Green Gables Metropolitan District # 1 (GGMD1)
Punch List for Acceptance of Public Improvements
September 29, 2023

In accordance with GGMD1's Public Infrastructure Acceptance Process, items below are to be addressed by Lennar prior to GGMD1 considering acceptance of such Public Improvements:

Feedback on Lennar Response to GGMD1 Punch List

January 5, 2024

Replace/ Reinstall mortar and missing stones on monuments.

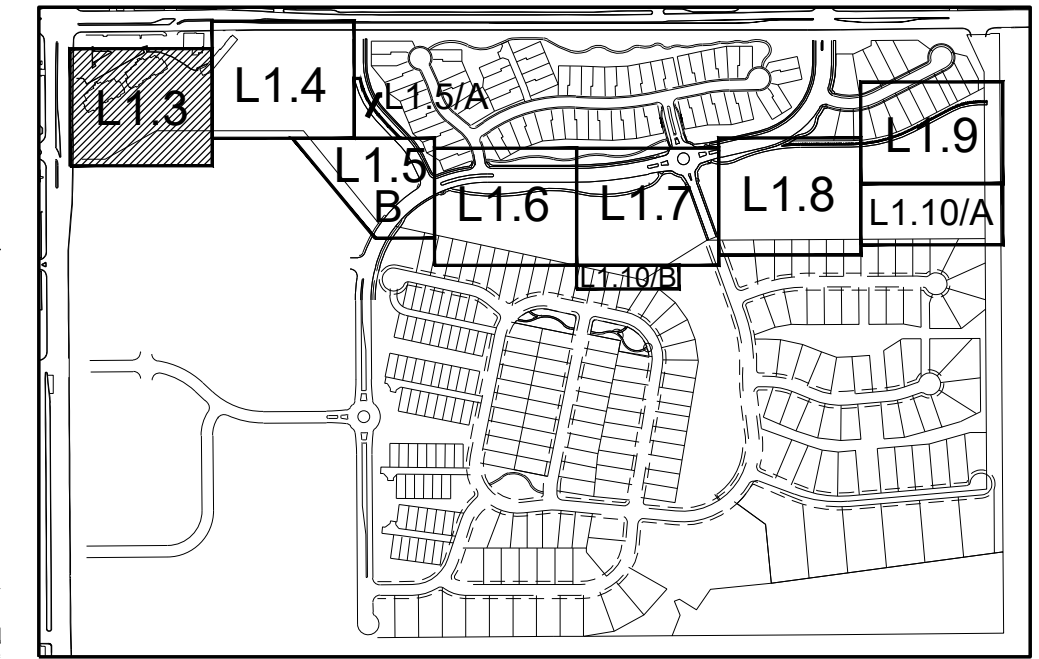
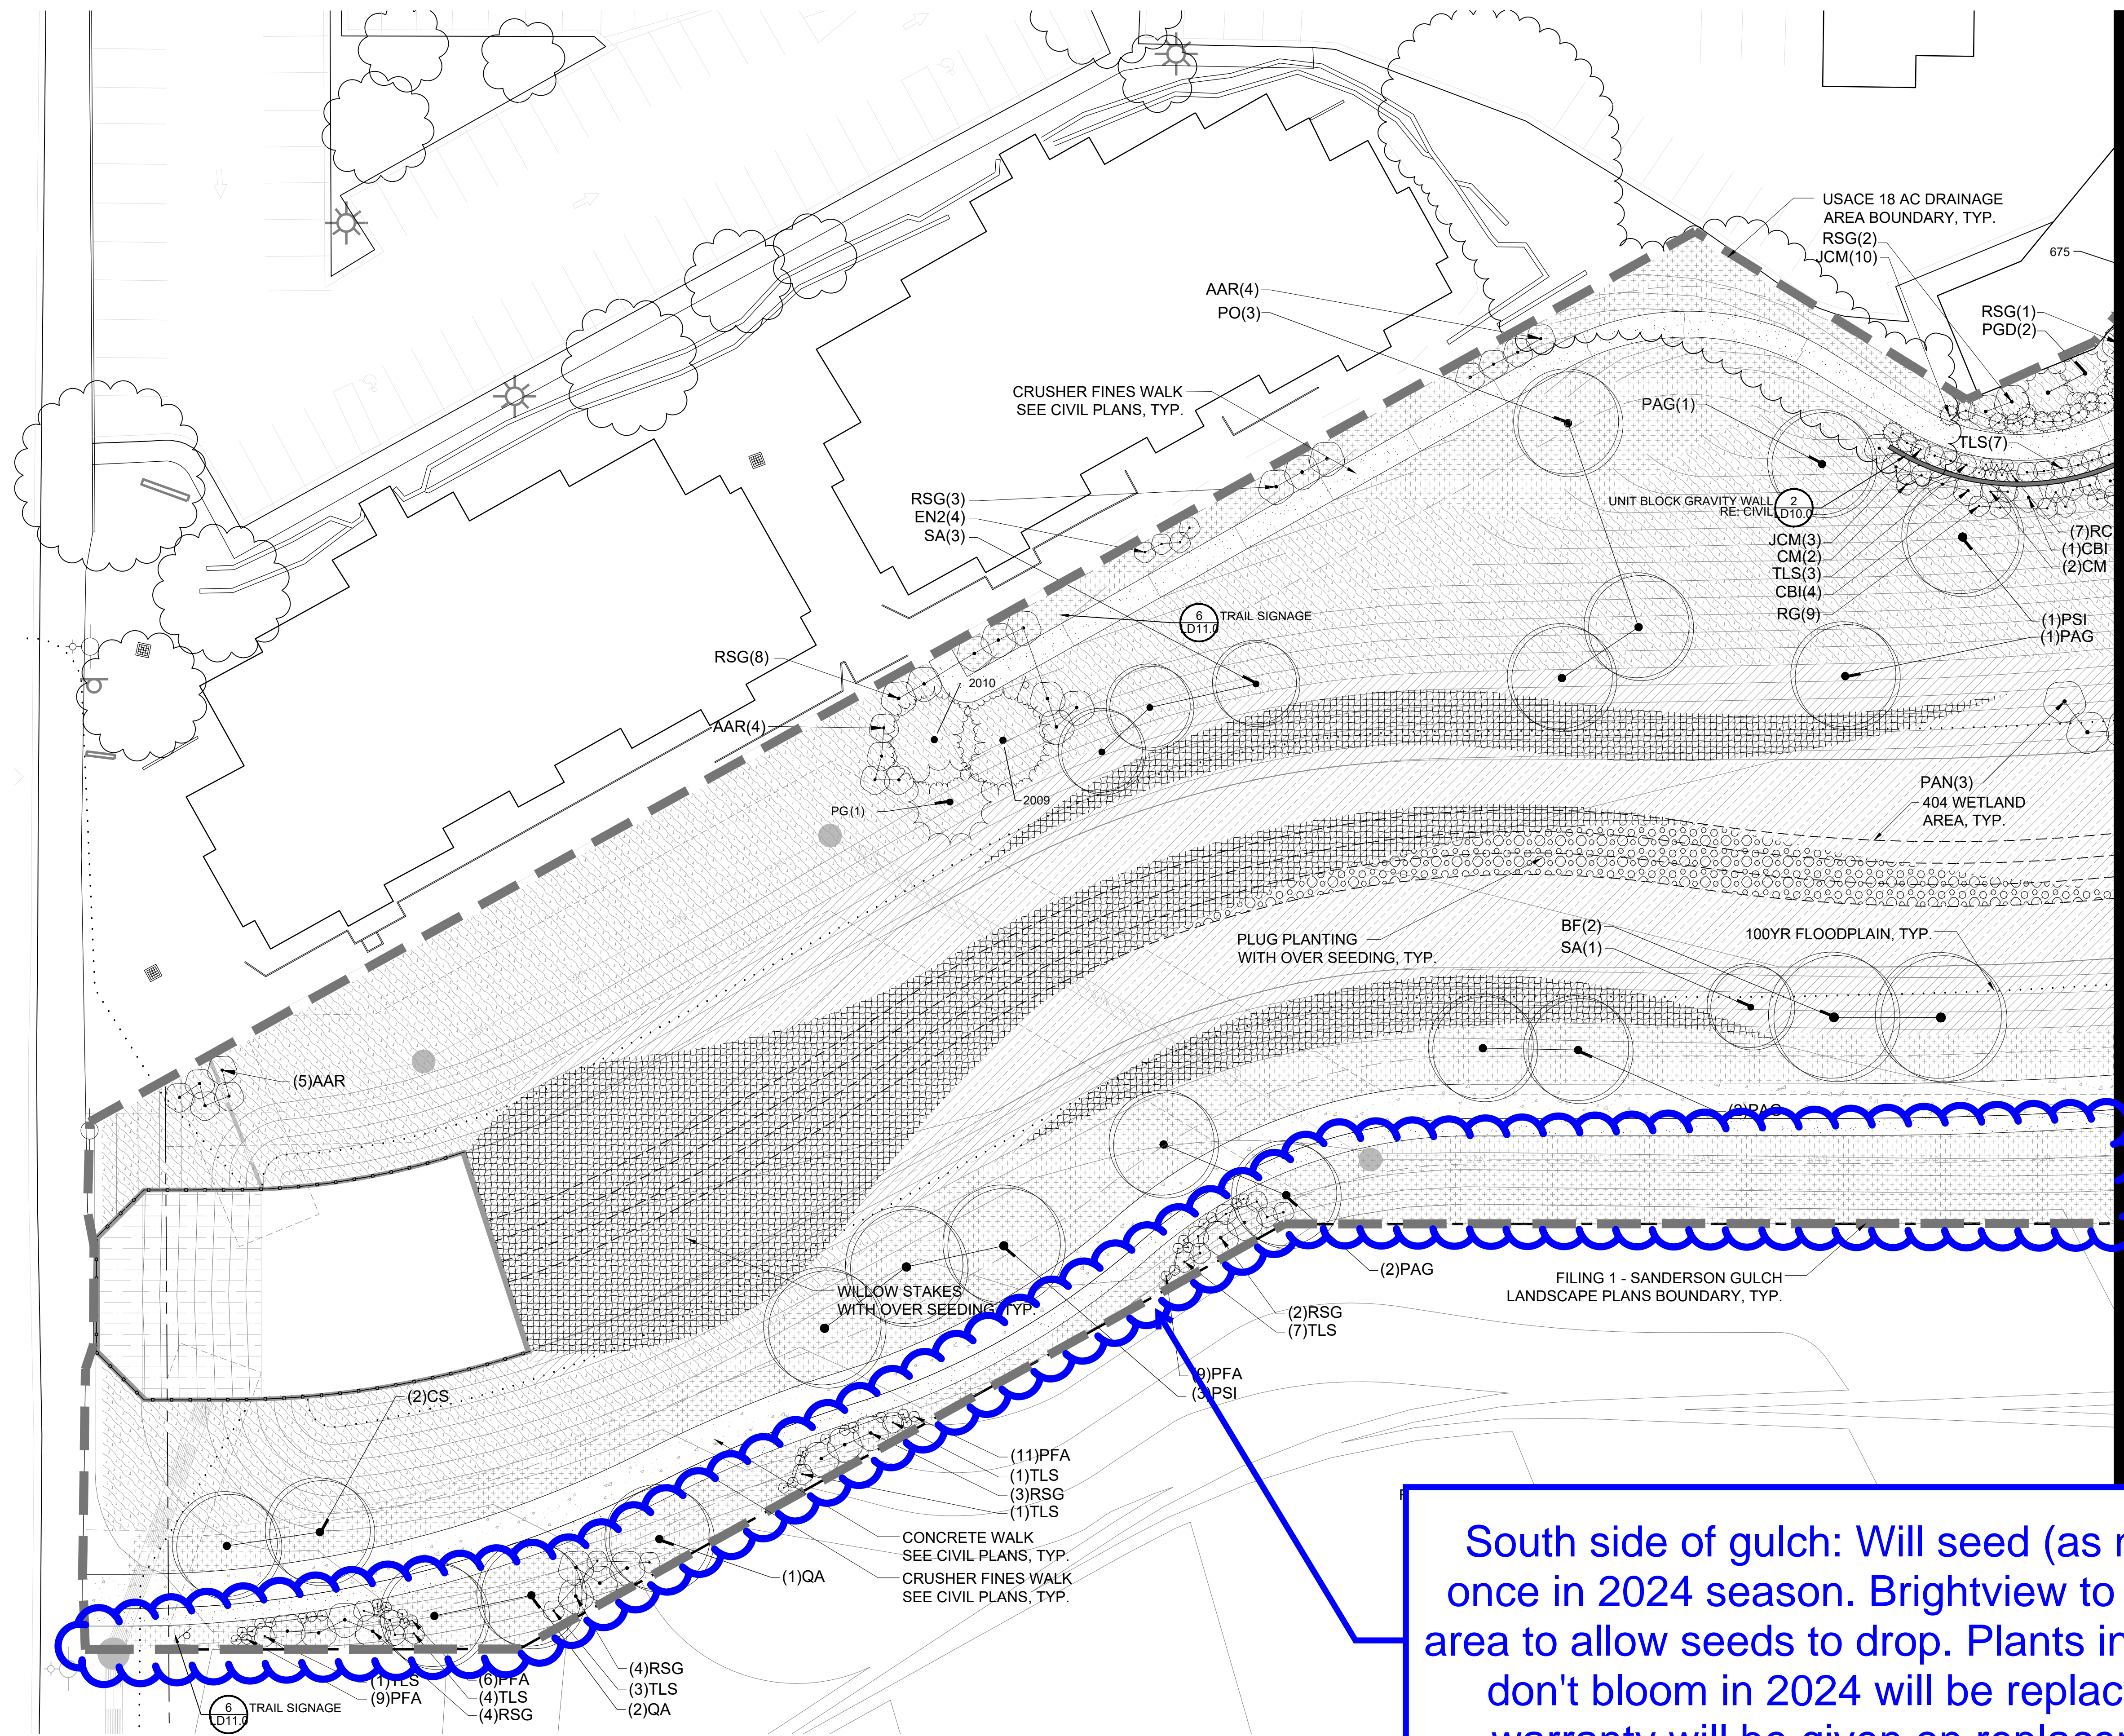
Cut relief joints every 4' at hand rail locations and caulk. Apply quickwall reinforced surface stucco to the existing cap.

Repair cracked stucco areas on monuments with quickwall reinforced surface stucco.

On the monument post locations we recommend adding a precast cap at top of wall and on rake to help prevent water penetration.

LANDSCAPE ARCHITECT		DEVELOPER	
GREEN GABLES		FILING 1 - SANDERSON GULCH	
LANDSCAPE PLANS		JEFFERSON COUNTY, COLORADO	
PLANTING LAYOUT		LANDSCAPE PLANS	
DATE 02.19.2016		VERIFY SCALE BAR IS ONE INCH ON ORIGINAL DRAWING	
FILE		DATE	
DWG		FILE	
SHEET L3.2		DWG

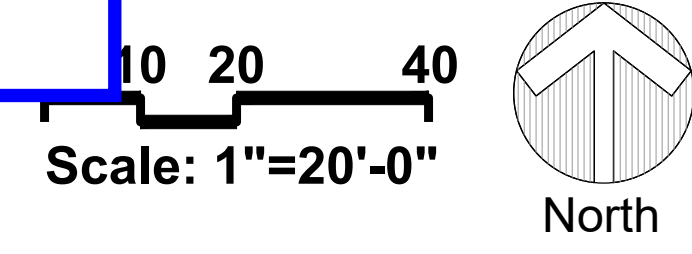
South side of gulch: Will seed (as needed) once in 2024 season. Brightview to not mow area to allow seeds to drop. Plants in area that don't bloom in 2024 will be replaced. No warranty will be given on replacements.
